Ratcliff Constructors, LP 4200 Beltway Drive Addison, Texas 75001 Phone: (972) 432-9969 Fax: (972) 432-9943 **Project:** 21-501 - Collin County Adult Detention Facility, Phase 1 Addition 4300 Community Avenue McKinney, Texas 75071

# Prime Contract Potential Change Order #081: RFI #243 Cell Modifications Rm 1327 & 1119

## RFI #243: Retro Fitting Rooms 1327 and 1119 for Padded Cells Per Alternate 5

## Room 1327

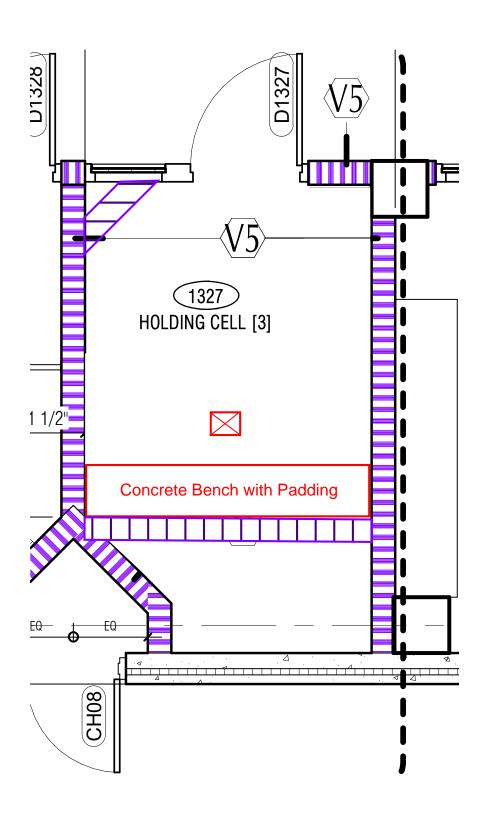
Provide for additional materials, labor, and equipment to install 1/4" steel infill plates to window lites and shutters to the outside of the doors in rooms 1327 and 1119. See back up including shutter detail to be used.

Refer to Layout of cell on next page. The signing of this PCO resolves the final completion/cost of this Alternate.
